SERVICE LETTER No. L 131

MODEL AFFECTED: Z 242 L aircraft, S/N: 0837, 0838, 0839

SUBJECT: Corrective action to prevent hydraulic fluid leakage from the K 22-1200-7 brake.

Fig. 1 The brake K22-1200-7 (positions numbers correspond to position numbers in IPC)

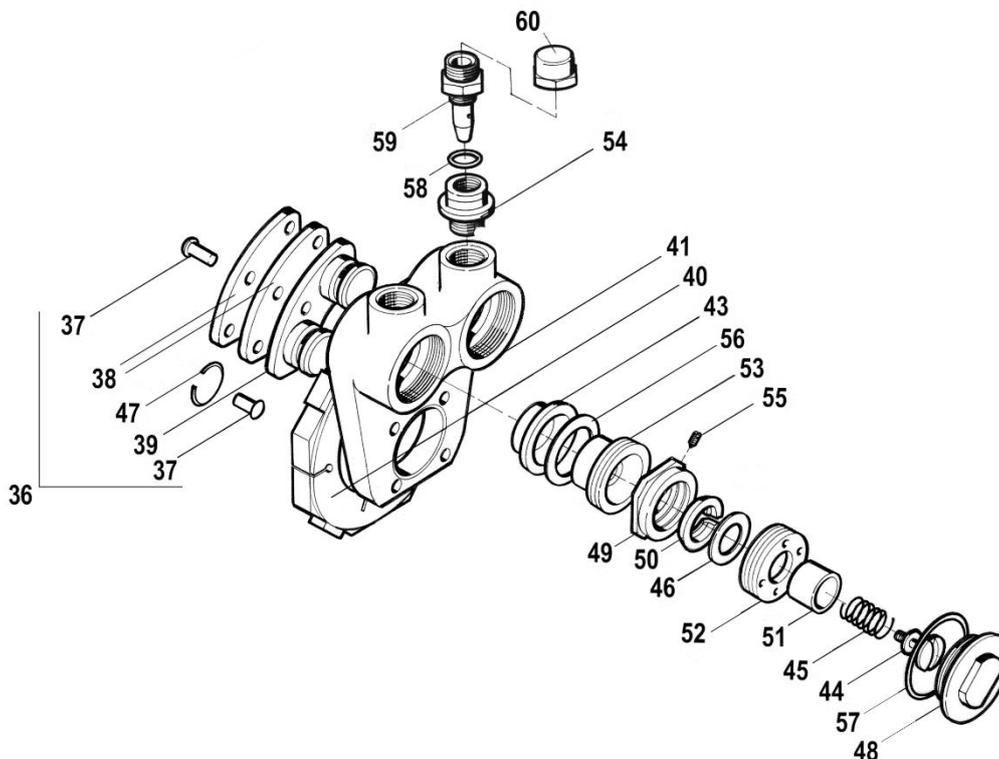
The leakage of hydraulic brake fluid can occur around the lid K22-0200.10 (item 48), as a solution of this cause, the manufacturer replaced the rubber O ring acc. to ČSN 02 9281.2 (item 57) with a dimension 48x2 with a more suitable "O" ring MS 28 775-135 with a dimension 48x2,5.

- a) Disconnect the brake from the aircraft hydraulic system (blind the outlet to the brake line). Loosen fixing screws and remove the brake from the landing gear axle,
- b) Remove the pistons (53) as follows (*performer only in case of brake leakage*):
 - loosen the lids (48) of working cylinder and push out the piston (53),
- c) Instead of the original rings (57) insert new „O“ rings (*delivered by the aircraft manufacturer*),
- d) Before reassembling the brake, wash carefully all parts with a suitable degreaser, dry them by compressed air and grease all functional parts with a suitable greaser.

Reassemble the brake by following the abovementioned steps in reverse order.
